HISTORIC PRESERVATION COMMISSION

SUBJECT: Work Permit #1029631- After the fact demolition of the garage and construction of a new garage

MONTGOMERY COUNTY HISTORIC PRESERVATION COMMISSION
STAFF REPORT

PROPOSAL: After the fact demolition of the garage and construction of a new garage

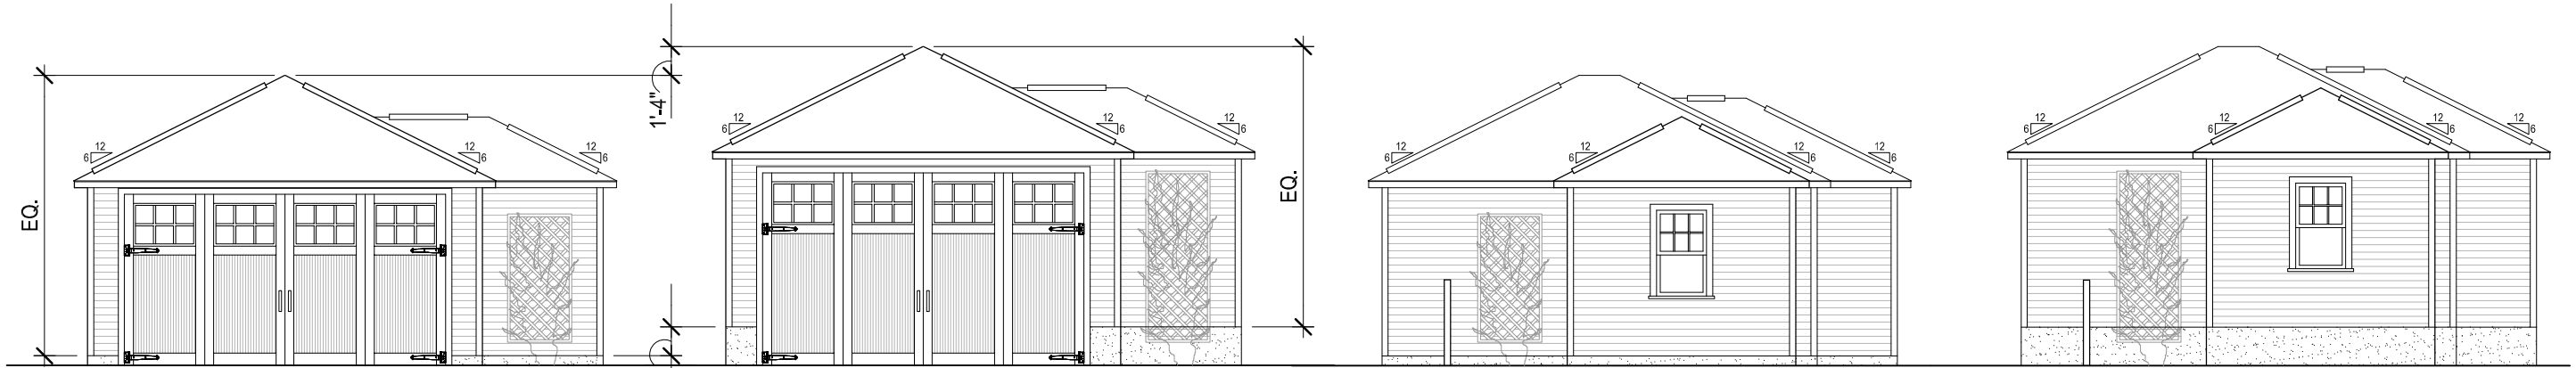
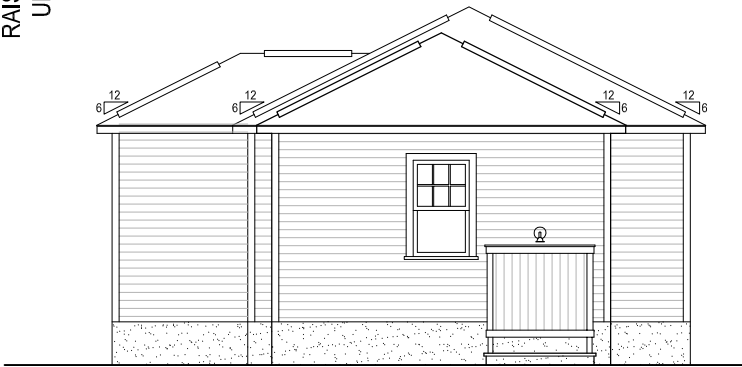
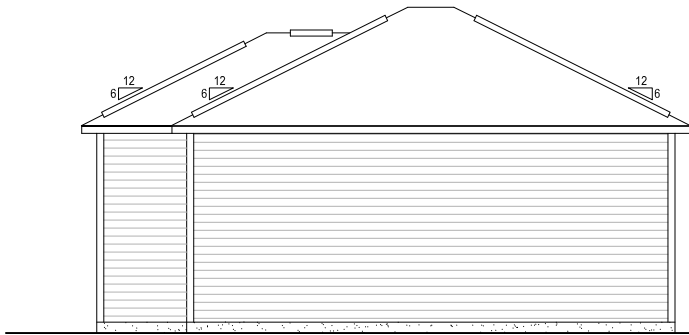
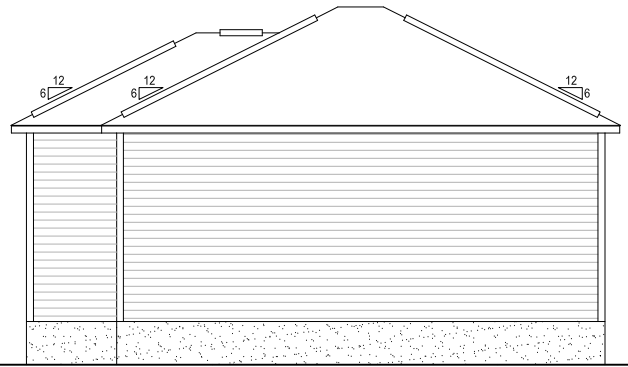
Proposal: The applicants propose to increase the height of the garage by 1'-4" by adding a CMU block foundation (two blocks high at 8" high per block). This revision is being proposed to accommodate two car lifts inside the garage.
